Contract #: 04-0120F4Cty: SF/ALA Rte: 80 PM: 13.2/13.9File #: 69.25B**QUALITY ASSURANCE -- NON-CONFORMANCE REPORT****Location:** Changxing Island, Shanghai, P.R. China**Report No:** NCR-000891**Prime Contractor:** American Bridge/Fluor Enterprises, a JV**Date:** 12-Nov-2010**Submitting Contractor:** Zhenhua Port Machinery Company, Ltd (ZPMC), Changxing Island**NCR #:** ZPMC-0853**Type of problem:**

Welding	Concrete	Other	
Welding	Curing	Procedural	Bridge No: 34-0006
Joint fit-up	Coating	Other	Component: Bikepath BK004A-025
Procedural	Procedural	Description: Reduced Plate Thickness

Reference Description: QA found the thickness of a plate is reduced in the bikepath after ZPMC had tested and accepted the weld visually

Job Name: SAS Superstructure
Document No: 05.03.06-000848

Description of Non-Conformance:

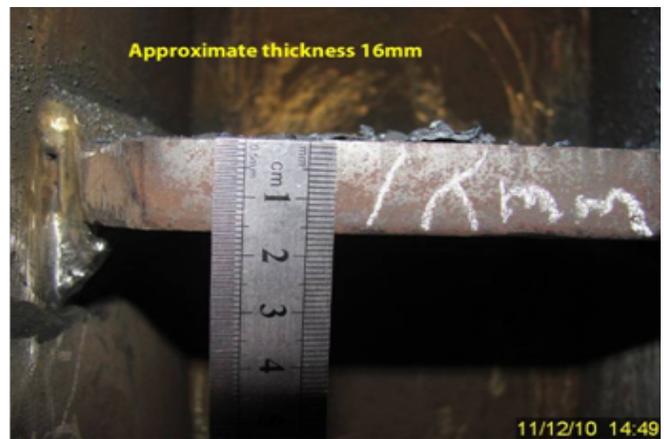
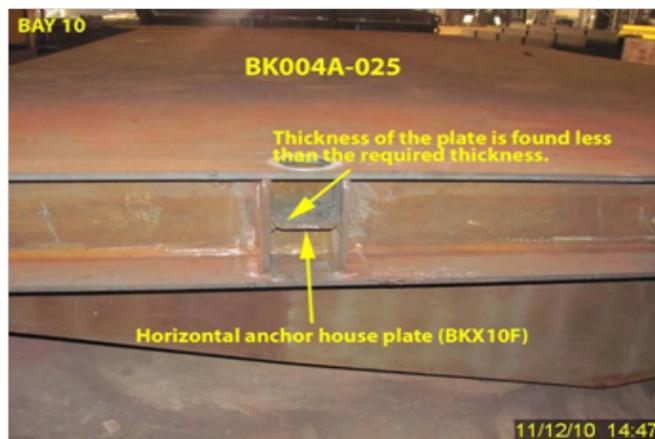
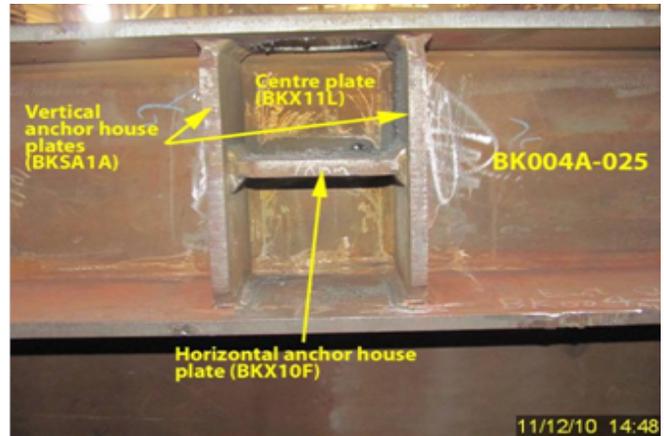
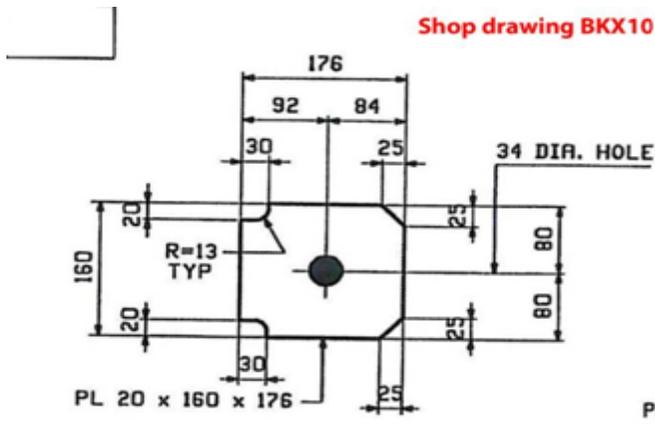
During the Quality Assurance (QA) Visual Testing (VT) verification of welds located on the vertical and horizontal anchor house plate of OBG bike path BK004A-025, this QA Inspector discovered the following issues:

- The thickness of an already welded horizontal anchor house plate (BKX10F) is found 4mm reduced uniformly in comparison to the approved shop drawings.
- As per shop drawing the required nominal thickness of the horizontal anchor house plate (BKX10F) is 20mm.
- The actual thickness of the BKX10F plate welded was found approximately 16mm.
- The material grade for the 16mm horizontal plate is unknown.
- This plate is located at east side of stringer plate 9C.
- The horizontal anchor house plate (BKX10F) joining the vertical anchor house plates and centre plate (BKX11L).
- The weld numbers are identified as; BK004A4-025-080, 100, 082, 101 and BK004A4-025-083, 102 respectively.
- The member is located in Bay 10.

The plate with incorrect thickness has been replaced with a plate of the correct thickness. ZPMC has issued an internal NCR to document this incident. This has been verified by the Department's inspectors see the attached notification for the date verified. Based on this ZPMC requests closure of this NCR.

The proposed resolution is acceptable. This NCR is considered closed.

Description of Non-Conformance:

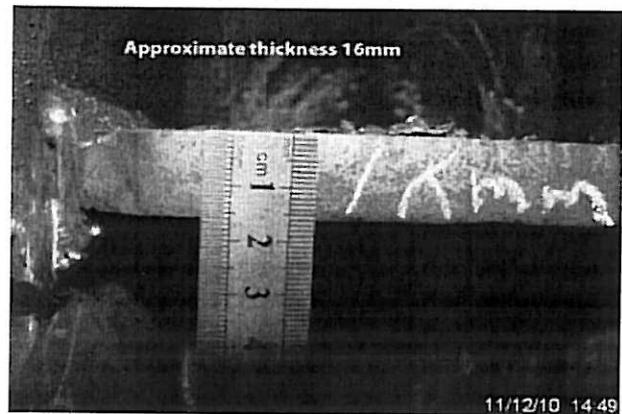
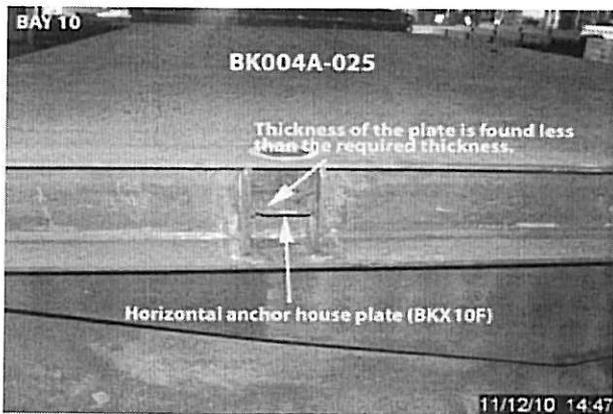
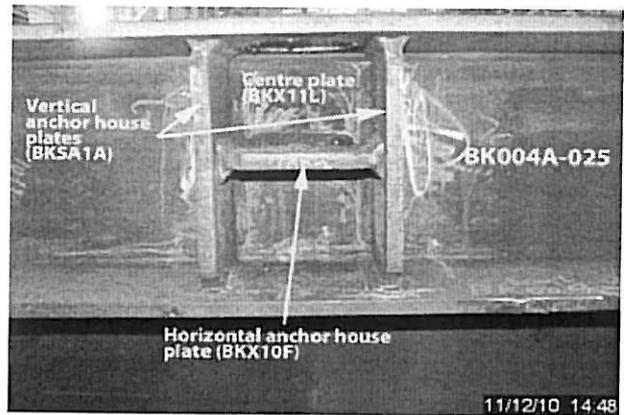
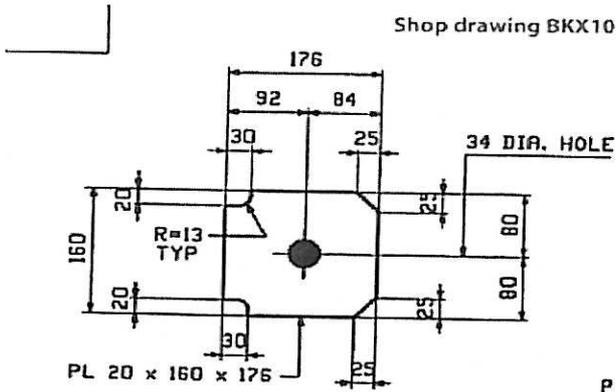
During the Quality Assurance (QA) Visual Testing (VT) verification of welds located on the vertical and horizontal anchor house plate of OBG bike path BK004A-025, this QA Inspector discovered the following issues:

- The thickness of an already welded horizontal anchor house plate (BKX10F) is found 4mm reduced uniformly in comparison to the approved shop drawings.
- As per shop drawing the required nominal thickness of the horizontal anchor house plate (BKX10F) is 20mm.
- The actual thickness of the BKX10F plate welded was found approximately 16mm.
- The material grade for the 16mm horizontal plate is unknown.
- This plate is located at east side of stringer plate 9C.
- The horizontal anchor house plate (BKX10F) joining the vertical anchor house plates and centre plate (BKX11L).
- The weld numbers are identified as; BK004A4-025-080, 100, 082, 101 and BK004A4-025-083, 102 respectively.
- The member is located in Bay 10.

Replace the non-conforming plate with a plate of correct thickness. Issue internal NCR to the parties involved.

The under thickness plate was replaced, verified by QA inspectors. Internal NCR was issued by ZPMC.
